London Borough of Richmond upon Thames Comments 6 November 2024
Teddington Direct River Abstraction Project
EIA Scoping Report (J698-AJ-C03X-TEDD-RP-EN-100007)
<b>Chapter 1: Introduction</b>
<p><u>Paragraph 1.1.5</u> - <b>AMEND SCOPING BOUNDARY</b> - EIA scoping Boundary does not include Hawker Centre and Park gate Playground both of which would be impacted by the project.</p> <p><u>Paragraph 1.4.1</u> - <b>CLARIFICATION</b> - Saying TW has a desalination plant that can supplement supplies at times of high demand is misleading. We understand it has worked 3 times in the last 12 years</p>
<b>Chapter 2: The Project</b>
<p><u>Paragraph 2.2.13 – 2.2.14</u> - <b>OMISSION METHODOLOGY</b> - To assess human and environmental risk, the EIA should <b>SCOPE IN</b> a requirement to provide evidence (including data) on the efficacy of the Mogden Tertiary Treatment Process (TTP) in reducing chemical and biological hazards in the wastewater intended for the TDRA. The evidence should also include how the Mogden TTP compares in terms of efficacy to tertiary treatment processes in operation elsewhere in the UK</p> <p><u>Paragraph 2.2.31</u> - <b>OMISSION</b> - the Intake description does not describ

*Figure 18.2 PROW Routes linking to the local affected road network south of the River Thames*

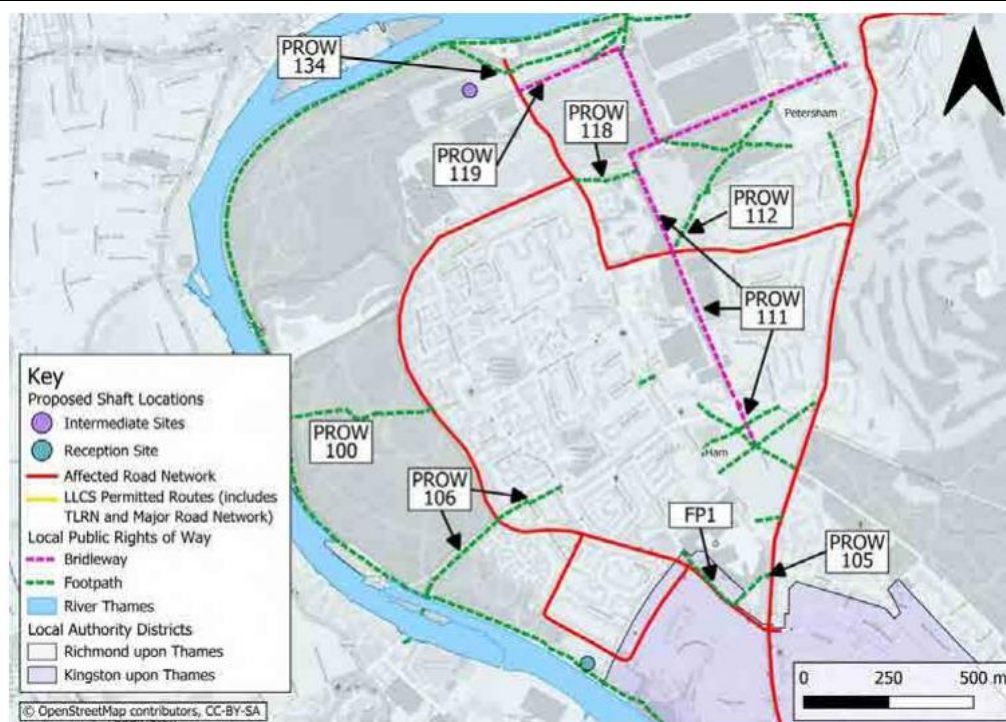
**Figure 18.2 – COMMENT** - It should be noted that the routes linking to the affected road network south of the river Thames are very congested, especially the route into Richmond via Petersham Road from Kingston
